NOTICE OF PROPOSED CHANGE IN PROPERTY

Petition: x1812

REQUEST TO OUTRIGHT VACATE
 A PORTION OF TRUMBULL AVE. 100 FT. WD.
 IN THE AREA BOUND BY
 COCHRANE, TRUMBULL, MICHIGAN AVE.
 AND W. FISHER FWY. SERVICE DR.

CITY OF DETROIT
 CITY ENGINEERING DEPARTMENT
 SURVEY BUREAU
 JOB NO. 01-01
 DRWG. NO. X 1812

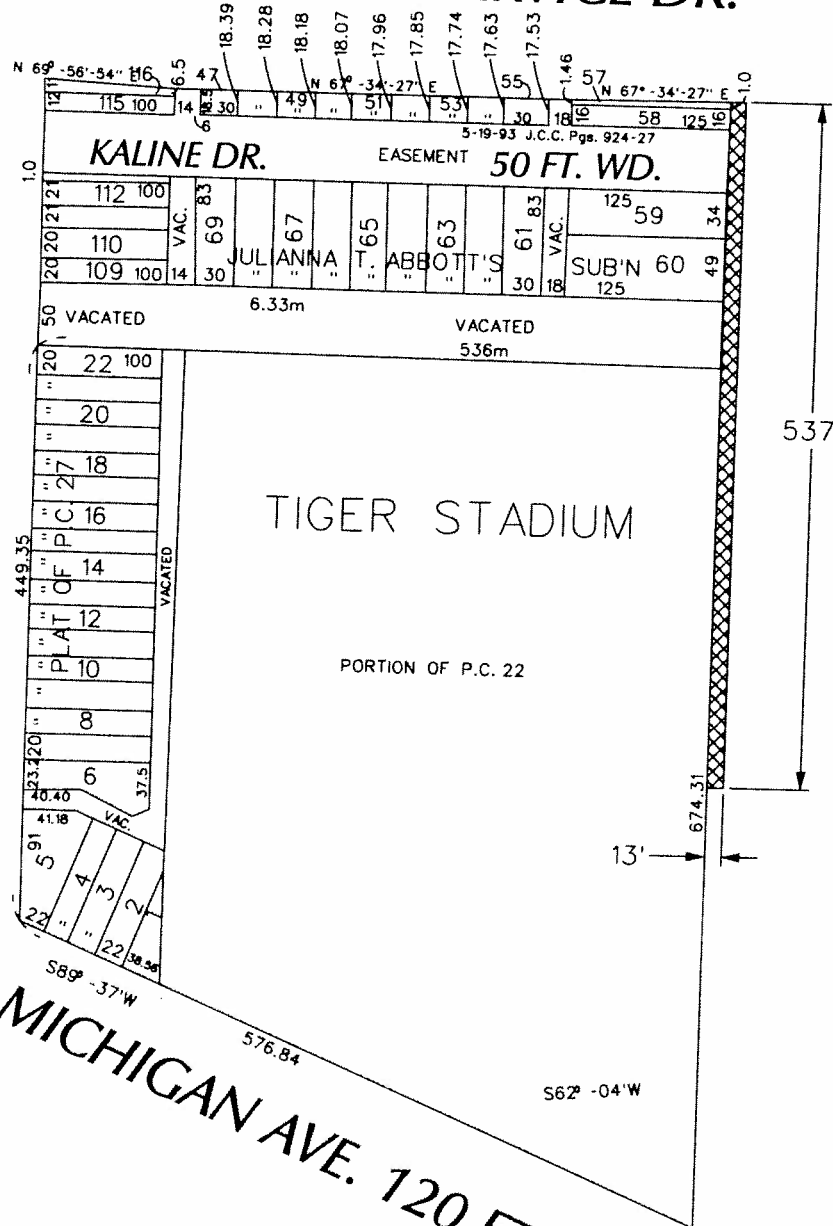
- Not Involved
- Involved; but asking you to hold action on this petition until further notice.
- Involved; but no objections to the property change.
- Involved; objection to the property change.**
P&DD has concerns with the safety at the intersection of Trumbull and Michigan Ave. DPW will need to approve any final striping plans that accommodate the traffic shift. Pedestrians will need to be accommodated during construction on the west side of Trumbull. The DPW Petition for outright vacation needs to be revised to include the west side of Trumbull for the entire length between the W. Fisher Freeway and Michigan Ave. in order to accommodate proper street alignment.
